November 5, 2012
RC-12-0170

Subject: VIRGIL C. SUMMER NUCLEAR STATION (VCSNS) UNIT 1
DOCKET NO. 50-395
OPERATING LICENSE NO. NPF-12
RELIEF REQUEST RR-III-09 SUPPLEMENTAL INFORMATION

VIRGIL C. SUMMER NUCLEAR STATION UNIT NO.1
REQUEST FOR ADDITIONAL INFORMATION
Relief Request RR-III-09
Alternative Weld Repair For Reactor Vessel Head Penetration
Additional Information

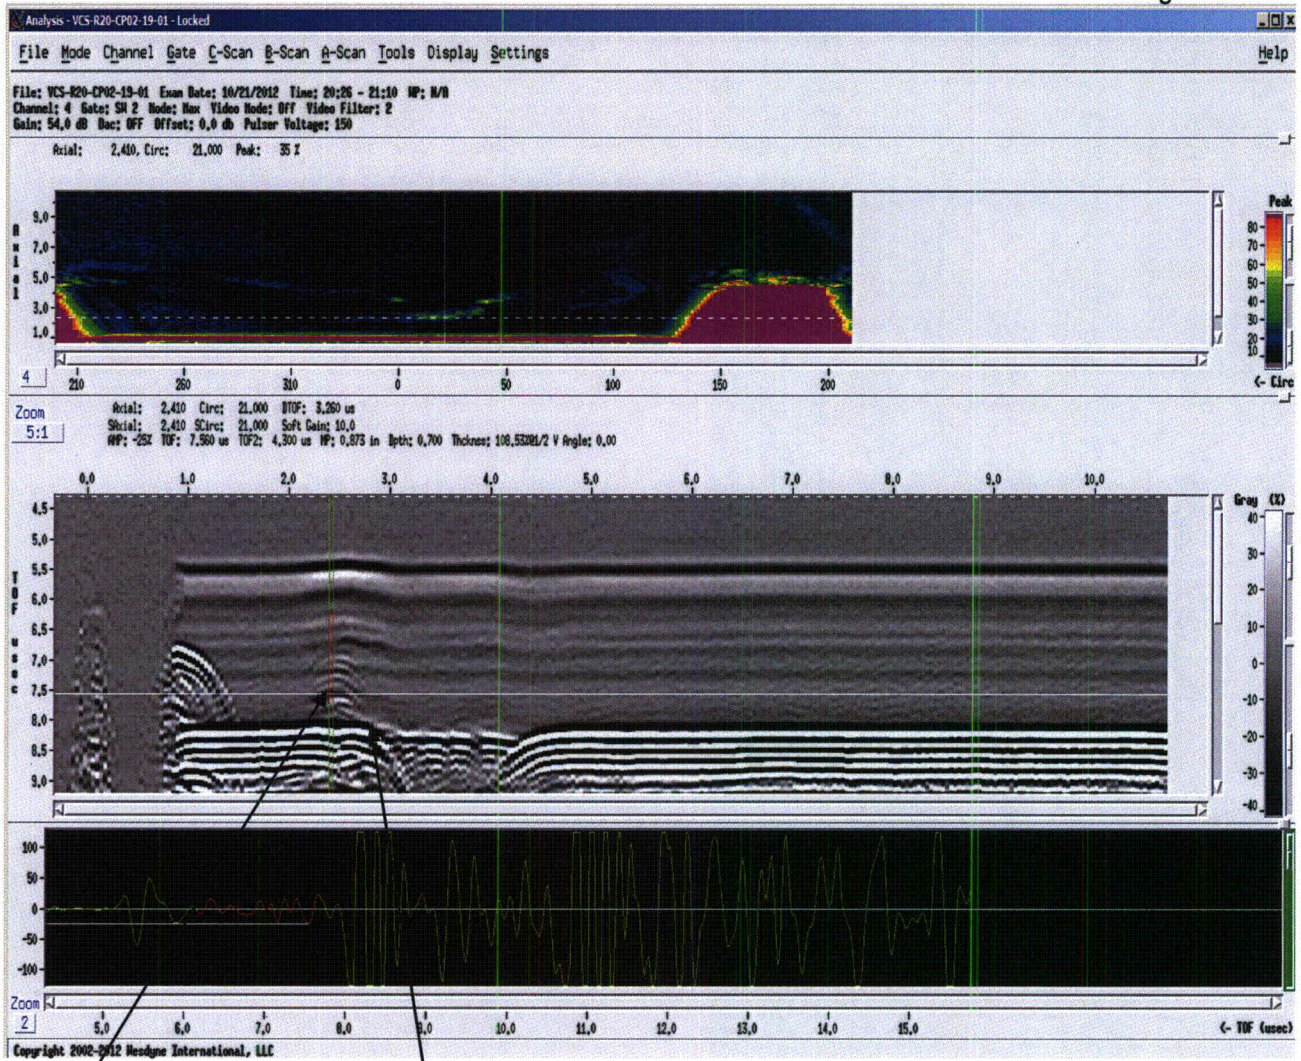
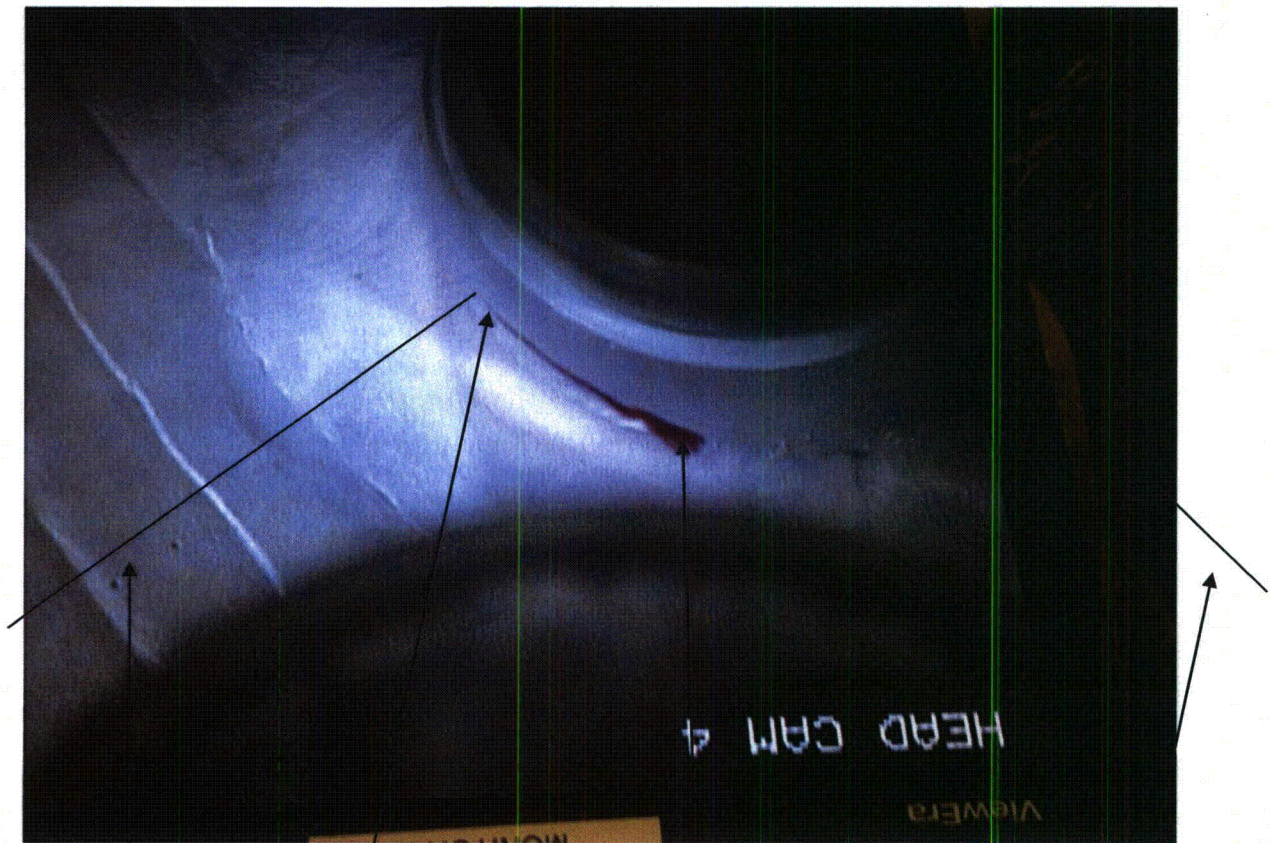
- 3. The flaw evaluation provided does not cover or analyze for a flaw located within the J-Groove weld. VCSNS should validate the flaw location and provide analyses if any of the weld areas are impacted by the flaw.**

The picture below shows the lower extent of the same indication flaw in Penetration #19. The flaw is further away from the weld toe, in the tube wall as it moves closer to Zero (Lowest Point of Weld).

This display of the flaw will look like it starts at the weld toe on the tube and hook down at an angle below the weld as it moves closer to the zero point as depicted in the PT Indication photo below.

PT Indication in Tube wall in Penetration 19: The circumferential indication is typical of a geometric artifact at the weld to nozzle interface. The elliptical area at the right edge of the PT indication is in the base metal and aligns with the UT indication results.

In the case of Penetration #19 for example, the UT report reported the flaw from 0 to 39°. The PT report shows a flaw starting at 0°, 1.5" long in the positive direction. This matches precisely.
